Oil Leakage on Cylinder Head Cover: Insert Micro-Self-Locking Screw (166/21)

Revision: This bulletin replaces bulletin Group 1 166/21, dated December 10, 2021.

Model Lines: **Panamera (971)**

Equipment: **8-cylinder Otto engine (engine type: CVD)**

Example of an oil leakage

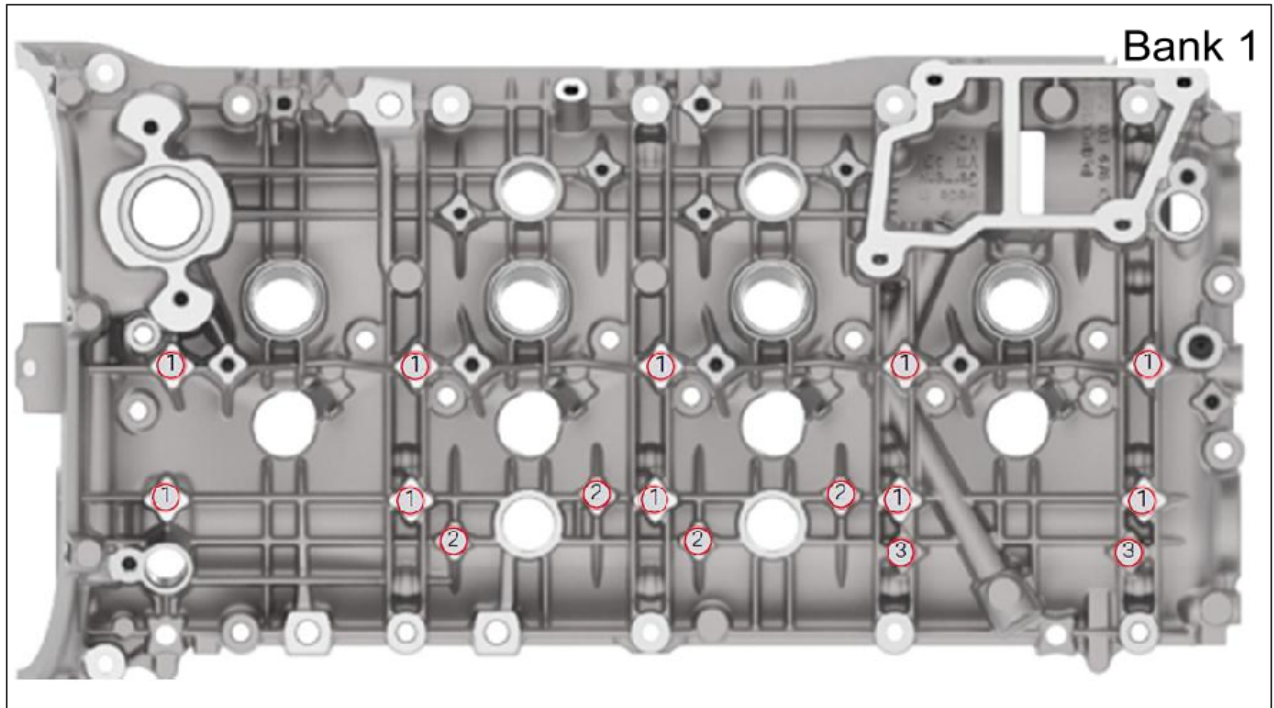
Cause: The customer complains about an oil leakage in the engine compartment. "Oil sweating" or drops of oil forming in the cylinder head cover area is detected in the workshop.

The measure described here relates to a potential oil leak at the screws shown on the cylinder head cover. If the oil leak occurs at another location, the oil leak must be found and remedied. This Technical Information (TI) does not apply in this case.

Action required: Clean the affected area thoroughly and replace the affected screws and adjacent screws with micro-self-locking screws.

Example of "adjacent screws"

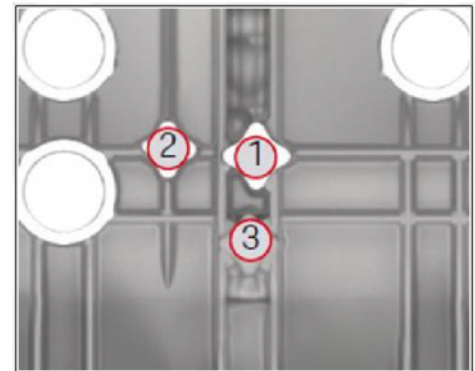
The surrounding screws around the leakage must in principle also be replaced with microencapsulated self-locking screws analogous to the example shown in the graphic ⇒ *Example of "adjacent screws"*.

- Work Procedure: 1 Unscrew the affected and adjacent screws.
- 2 Clean the affected area thoroughly.
 - 3 Blow out bores using compressed air.
 - 4 Screw in and tighten new micro-self-locking screws at the relevant position.
Check the following while doing this:
 - Screws for fuel collection pipe (item 1) **Initial tightening 7 Nm (5.2 ftlb.) Final tightening 10 Nm (7.4 ftlb.)** Also observe screw sequence. For instructions, see: ⇒ *Workshop Manual '243019 Removing and installing fuel collection pipe (V8 biturbo)'*
 - Screw for solenoid hydraulic valve VHS (item 2) **Tightening torque 5 Nm (3.7 ftlb.)**
 - Screws for pressure converter holder (item 3) **Tightening torque 10 Nm (7.4 ftlb.)**
